35-TYPE CONVERTER SETS — ADJUSTMENTS

APPARATUS AFFECTED: 35A, 35B, 35D, 35E, 35F, 35G and 35H Converter Sets.

- (1) To simplify adjustment methods and requirements.
- (2) To revise and update wiring diagrams.

4.19 GEAR MECHANISM**(A) INTERMEDIATE SHAFT
REQUIREMENT**

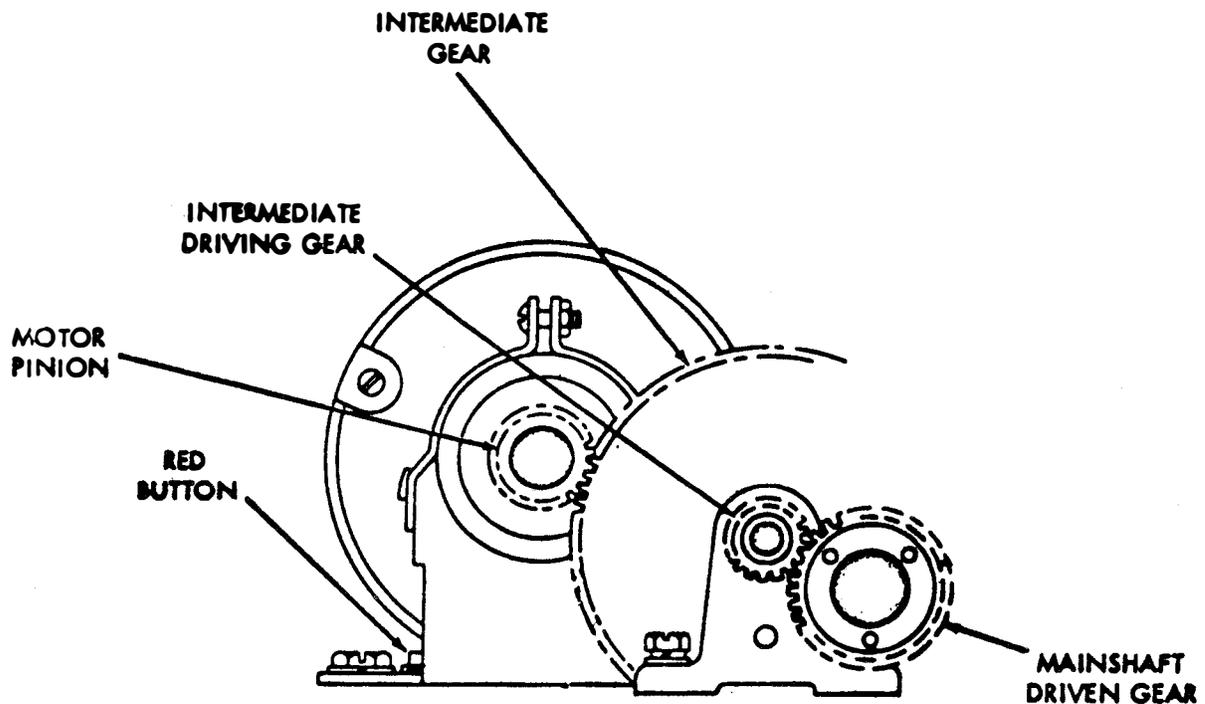
(A) Tape Reader Gear Backlash

The location of subparagraph (A) on page 30 has been changed and will read as subparagraph (B) Tape Reader Gear Backlash.

The requirement (A) Tape Reader Gear Backlash has been changed:

From: "Only a perceptible amount of backlash between main shaft driven gear and intermediate driving gear."

To: "Only a perceptible amount of backlash between main shaft driven gear and intermediate driving gear at point where backlash is least."

(B) Intermediate Shaft

The location of subparagraph (B) on page 30 has been changed and will read as subparagraph (A) Intermediate Shaft.

The requirement of Min. 0.015 inch—Max. 0.020 inch has been deleted.

"To Adjust" of new (A) Intermediate Shaft, has been changed:

From: To Adjust.

Position the intermediate shaft assembly to the forward plate loosened.

To: To Adjust.

Loosen the two intermediate gear bracket screws and position intermediate gear bracket.

The note to subparagraph (B) Intermediate Shaft, has been changed:

From: Note: Intermediate shaft adjustment required only on miniaturized base.

To: Note: In some cases, it may be necessary to loosen the motor mounting screws and position the motor to meet the requirements.

ONLY A PERCEPTIBLE AMOUNT OF BACKLASH BETWEEN THE MOTOR PINION
AND INTERMEDIATE GEAR AT POINT WHERE BACKLASH IS LEAST.

TO ADJUST

LOOSEN THE TWO INTERMEDIATE GEAR BRACKET SCREWS AND POSITION
INTERMEDIATE GEAR BRACKET.

NOTE: IN SOME CASES IT MAY BE NECESSARY TO LOOSEN THE MOTOR
MOUNTING SCREWS AND POSITION THE MOTOR TO MEET THE
REQUIREMENT.

**(B) TAPE READER GEAR BACKLASH****REQUIREMENT**

ONLY A PERCEPTIBLE AMOUNT OF BACKLASH BETWEEN MAINSHAFT DRIVEN GEAR
AND INTERMEDIATE DRIVING GEAR AT POINT WHERE BACKLASH IS LEAST.

TO ADJUST

LOOSEN THREE TAPE READER MOUNTING SCREWS AND POSITION TAPE READER.
